Subject: Submittal of the Response to the Notice of Disapproval for the Investigation Work Plan for Upper Sandia Canyon Aggregate Area and Revision 1

Cross-Reference of NMED NOD Comments and Revisions to Upper Sandia Investigation Work Plan

Figure 4.1-5 Map A proposed sampling locations

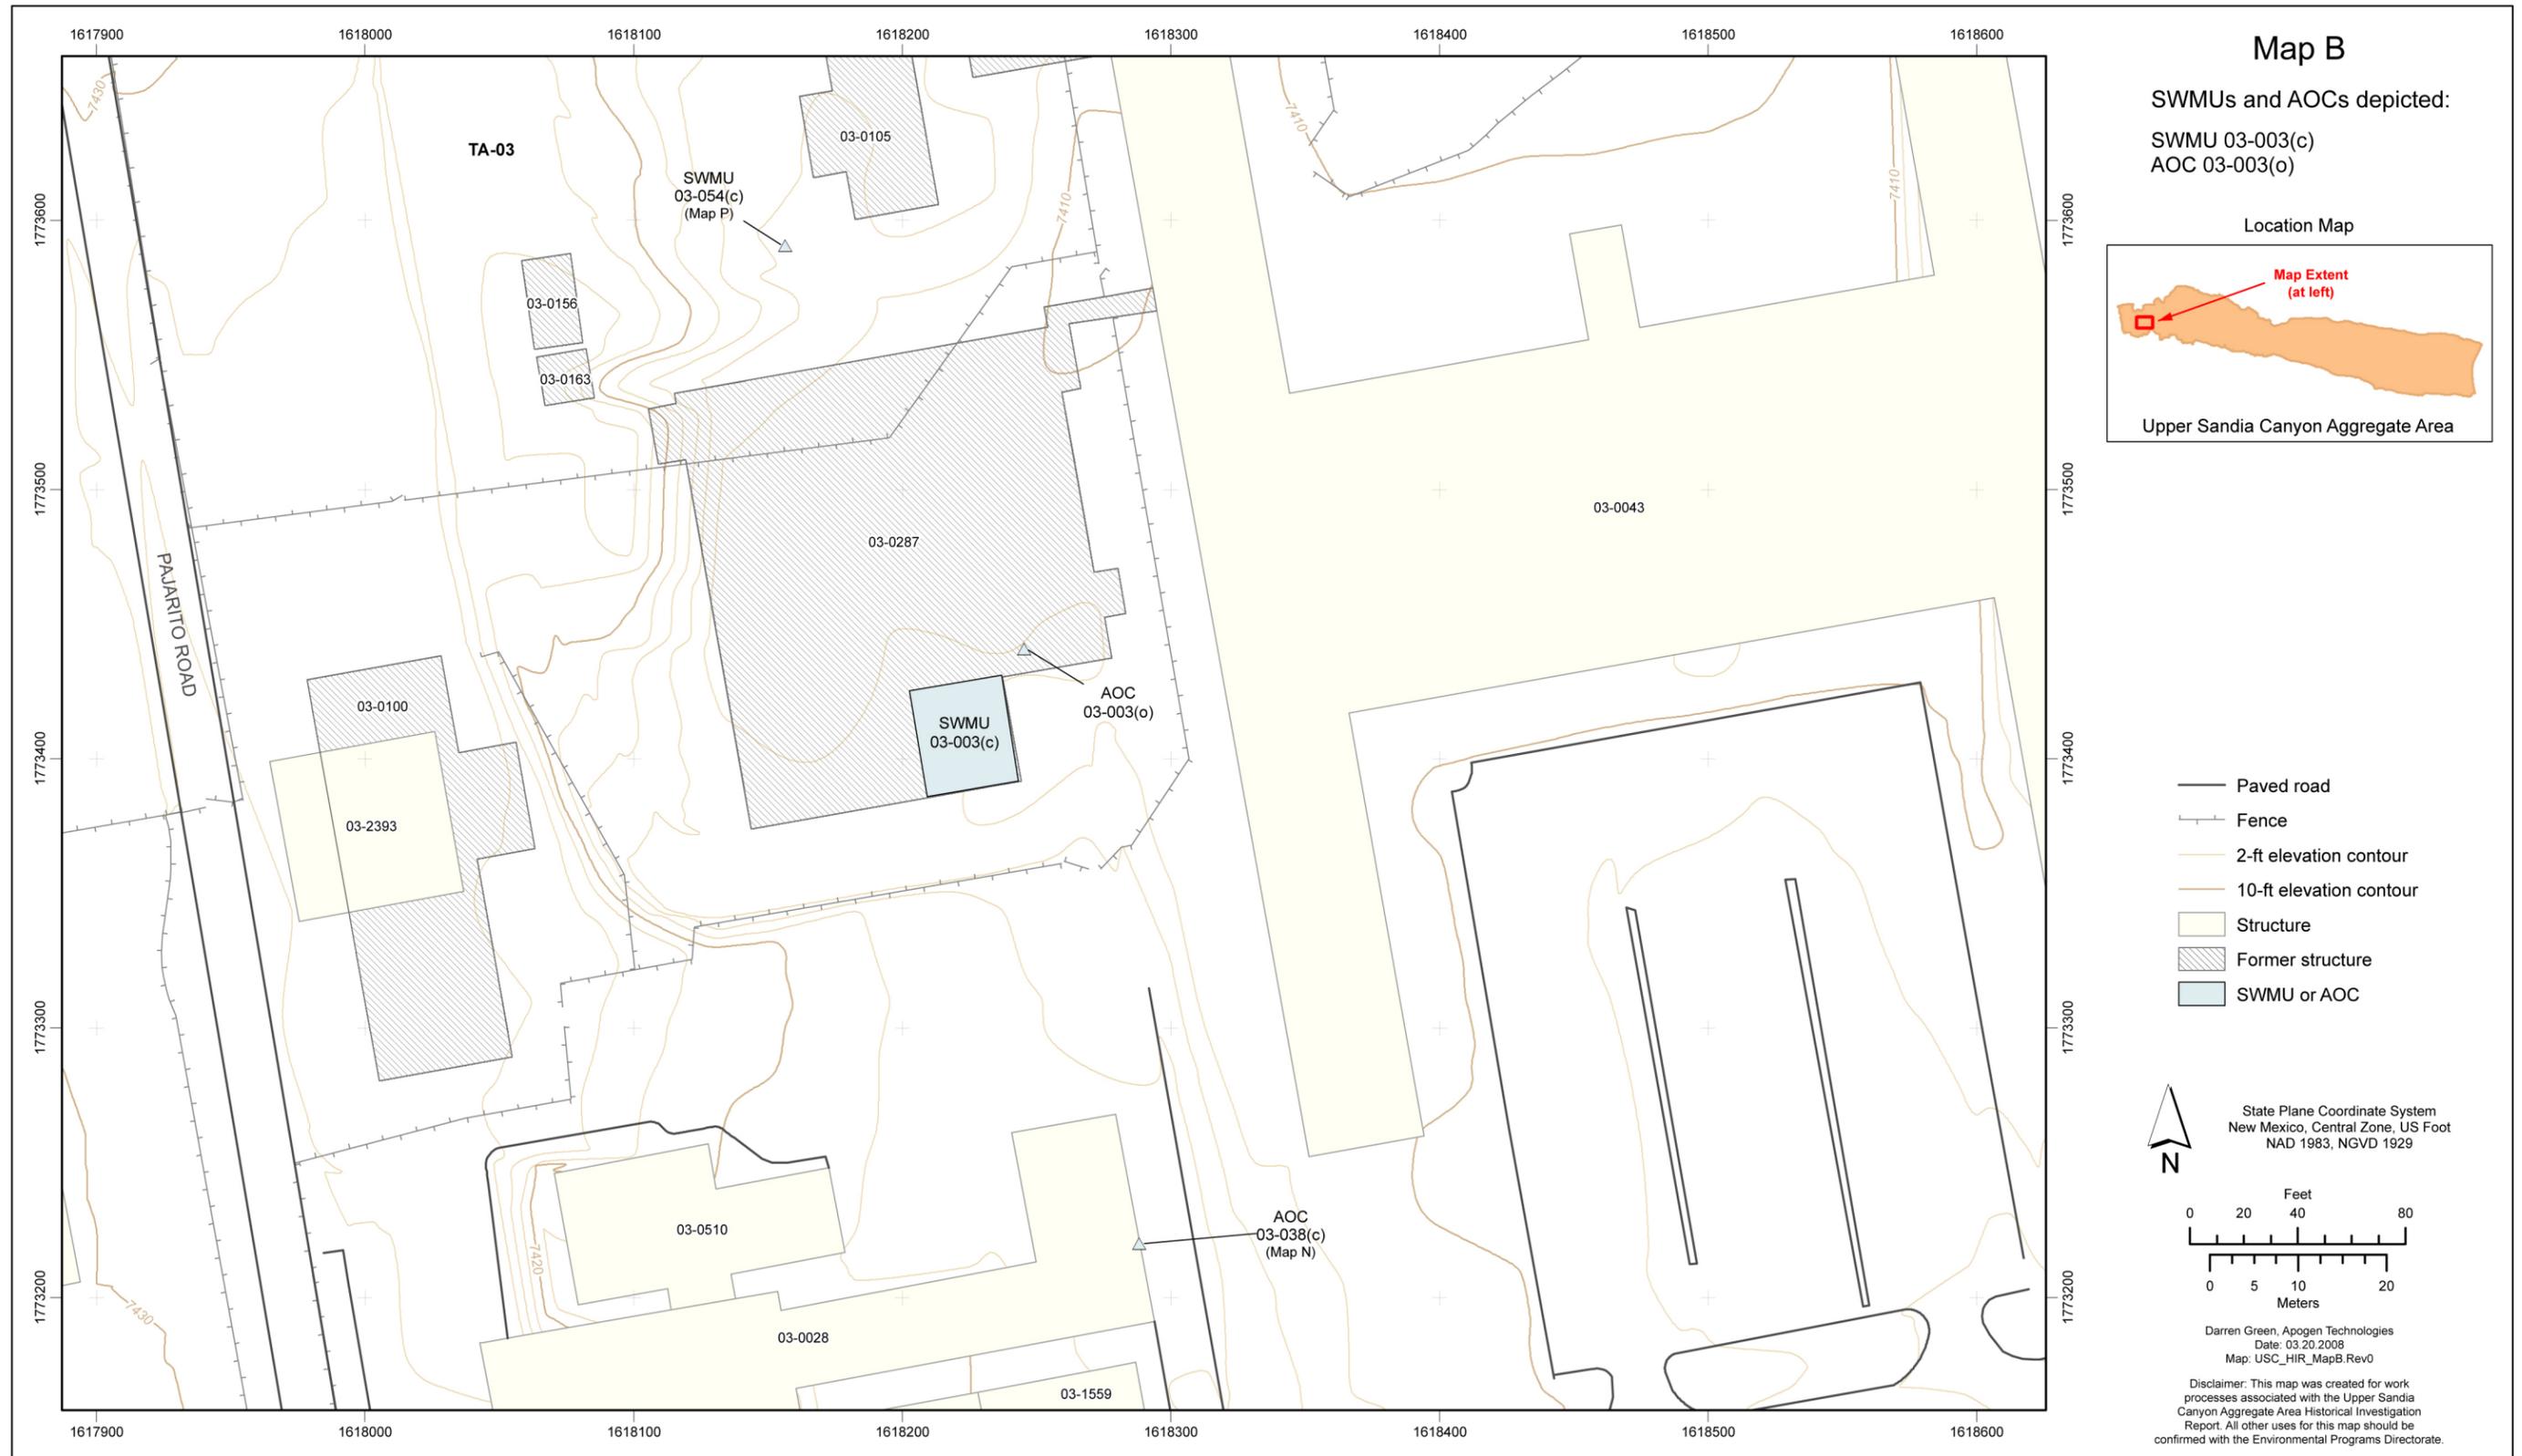
3	For SWMU 03-009(a), the Permittees must indicate proposed and existing sampling locations in canyons on the relevant figures.	Section 4.1.7.1 and Figure 4.1-5	Section 4.1.7.1 and Figure 4.1-5	The text has been revised to reference the canyon reach sediment sampling locations and to clarify that these data will be assessed in the Upper Sandia Canyon Aggregate Area investigation report. The corresponding figure has been revised to show relevant canyon reach and canyon sediment sampling locations.

Figure 4.1-5 has been revised to show the two sampling locations associated with SWMU 03-045(g), downgradient of SWMU 03-009(a), and to show the canyon reach (S-1 North) and canyon reach sediment sampling locations.

Figure 4.1-5 and the text in section 4.1.7.2 of the work plan have been revised accordingly.

Figure 4.1-12 Map C proposed sampling locations

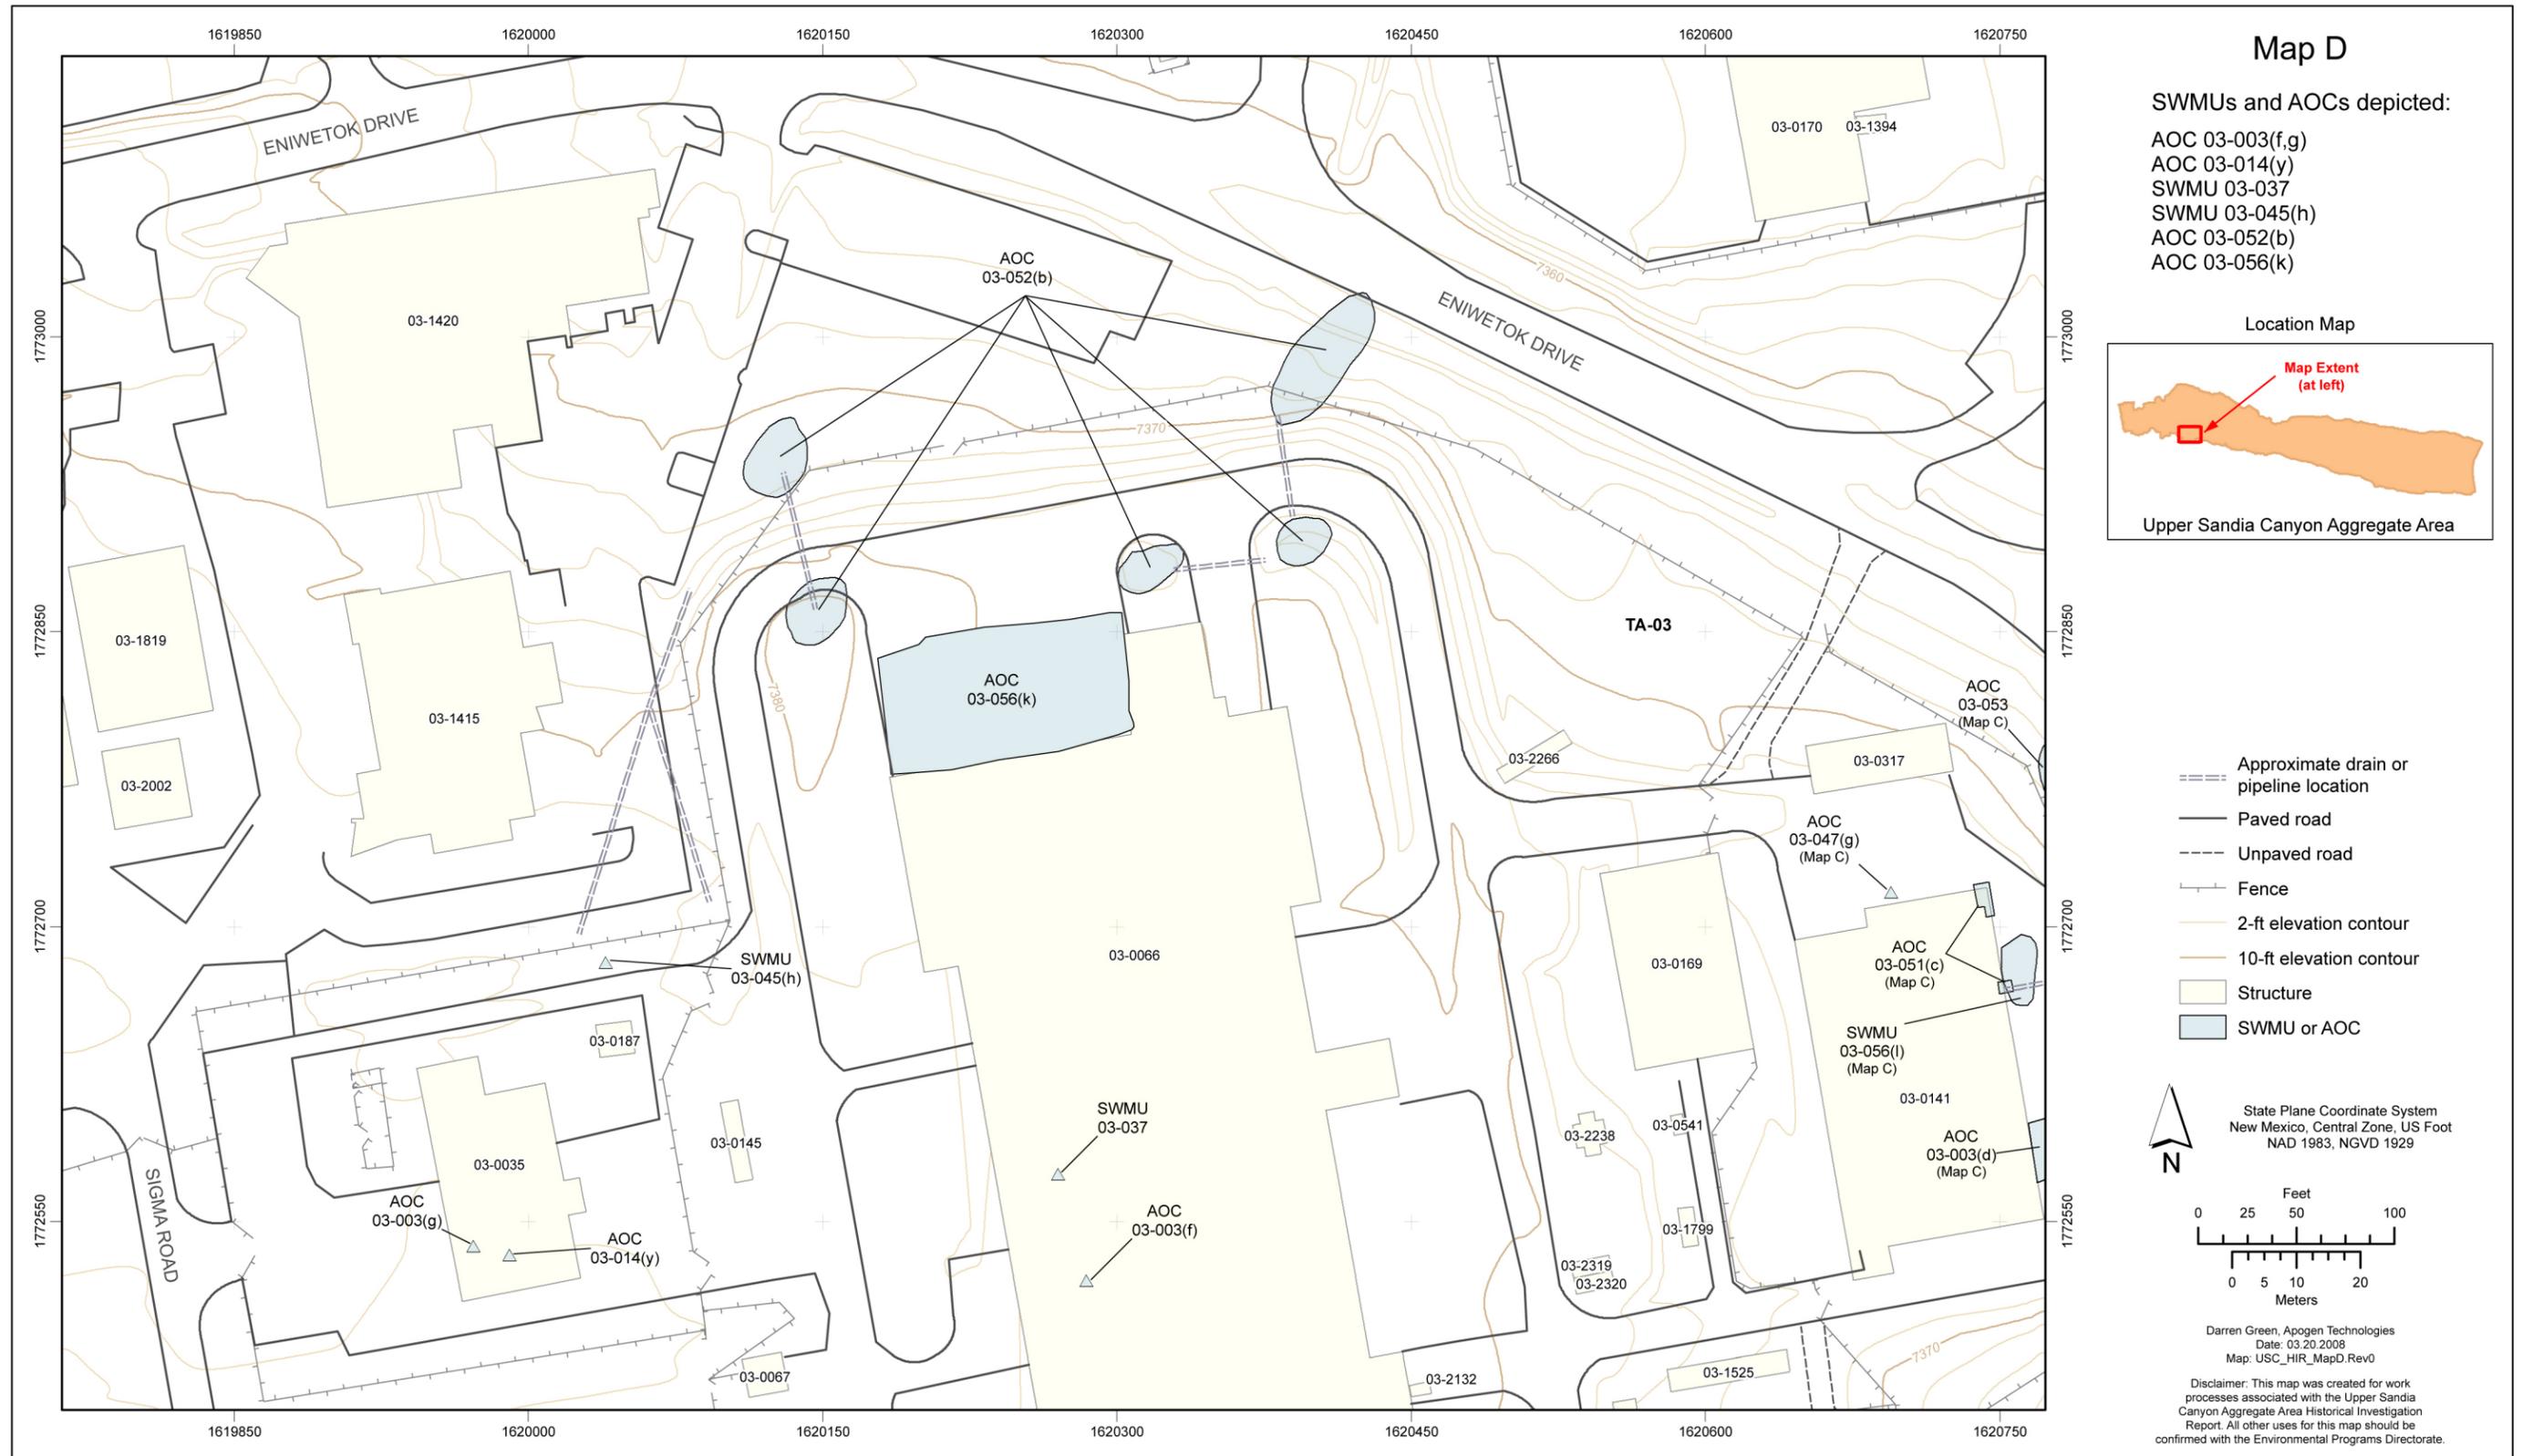
top of the slope to the toe of the colluvium. It is not clear from Figure 4.1-12, if the Permittees propose to collect samples along the entire length of the drainage to the toe of the colluvium. The Permittees must revise the Figure to depict the proposed sampling locations (see General Comment # 3).

1. Section 4.1.3 has been revised to indicate that soil samples will be collected from two depth intervals at two additional locations under the concrete pad (Figure 4.1-12) and to note that the chip samples will be collected from the old pad. Samples will be collected from the 0- to 1-ft interval and from the 1- to 2-ft interval below ground surface (bgs) and analyzed for PCBs. The proposed samples are presented in Table 4.0-1.

17. Figure 4.1-12 has been revised to show the drainage below the SWMU 03-015 outfall, one additional sampling location beneath the former drainline, and two additional sampling locations in the drainage northeast of the site. The text in section 4.1.18.1 and Table 4.0-1 have been revised accordingly.
